SERVICE BULLETIN

PURPOSE : INFORMATION	ISSUE NO. : MSB-11E11-006	DATE : 2011-11-20
SUBJECT : ID MARK ON CONNECTING ROD AND CRANKSHAFT BEARINGS FOR 3A9 AND 4A9 ENGINES		<MODEL> (EUR) Vehicles equipped with 3A9 or 4A9 engine / <M/Y> ALL
GROUP : ENGINE

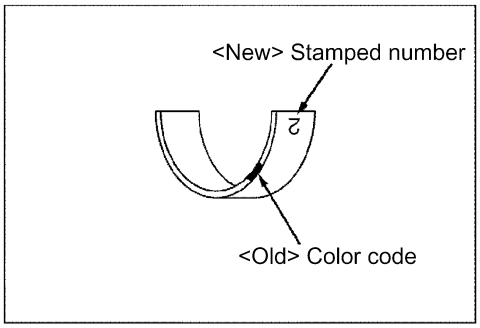
The identification marking is changed from a paint color code to a stamped number. The location of the mark is also changed.

Connecting rod bearing	
New (stamped number)	Old (color code)
1	Blue
2	Black
3	Red
